COMMUNITY DEVELOPMENT DEPARTMENT REPORT

HEARING DATE: 7/8/2025

SUBJECT: FP-2025-0002
Hadler Subdivision No 2 Final Plat

B. Final Plat (date: 1/13/2025)

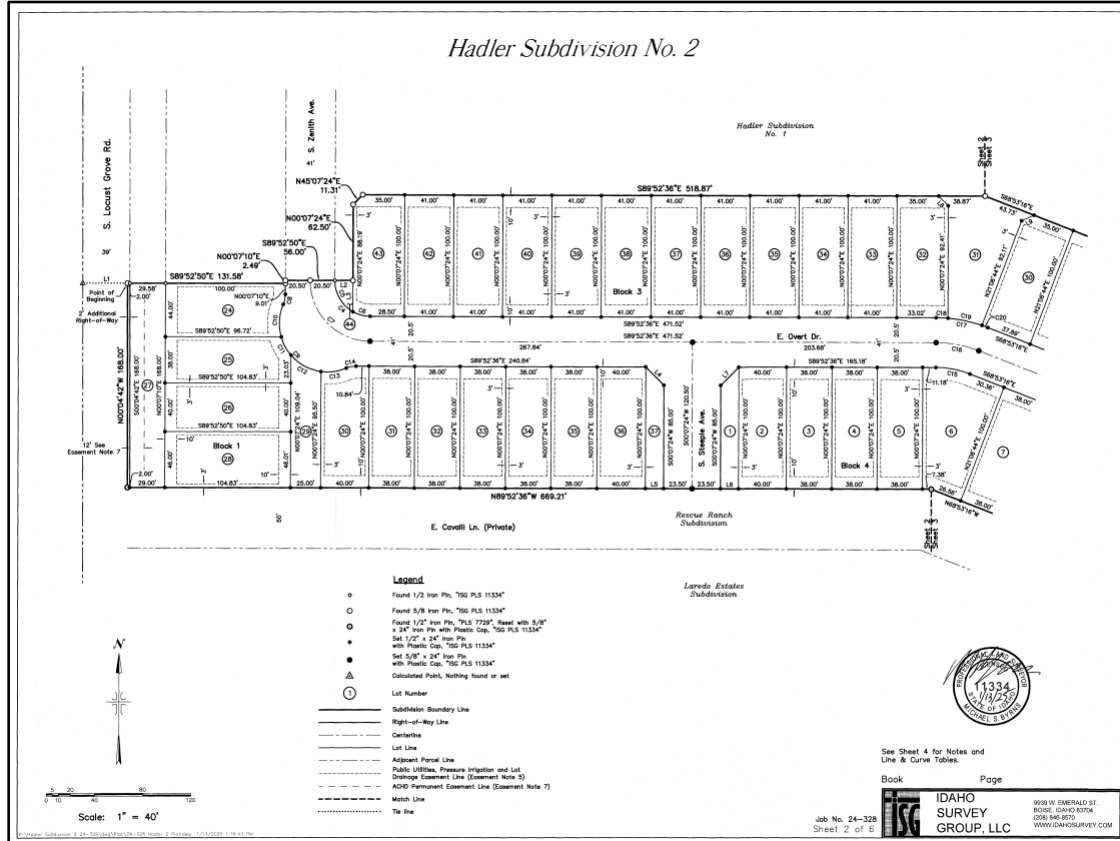
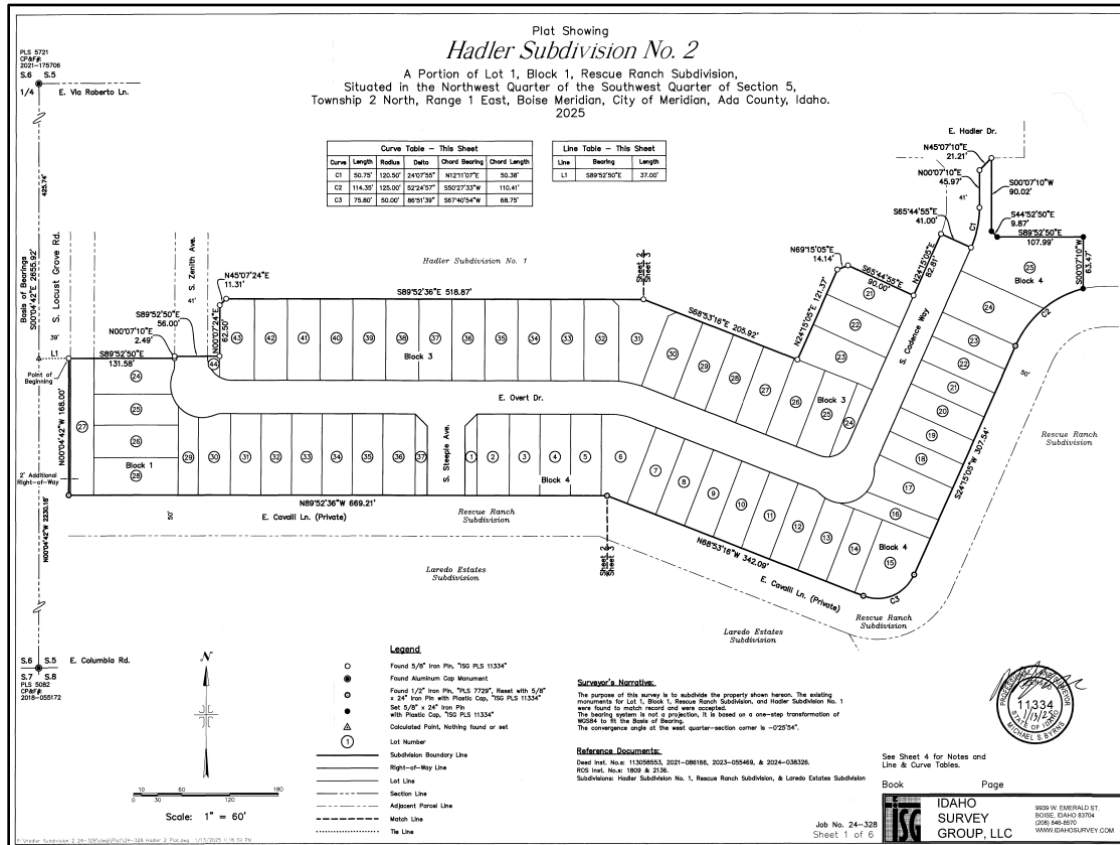
1. Applicant shall comply with all previous conditions of approval associated with this development: H-2022-0064 (AZ, PP) and DA Inst. #2023-023846.
2. The final plat shown in Section V.B, prepared by Idaho Survey Group, LLC, stamped on 1/13/25 by Michael S. Byrns, shall be revised prior to signature on the final plat by the City Engineer, as follows:

- a. Note #9: Include the instrument number for the ACHD license agreement
 - b. Easement Note #6: Include the instrument number for the ACHD permanent easement.

- c. Include the recorded instrument number of the City of Meridian water easement.
3. The landscape plan prepared by Jensenbelts Associates, dated December 30, 2024, is approved as submitted.
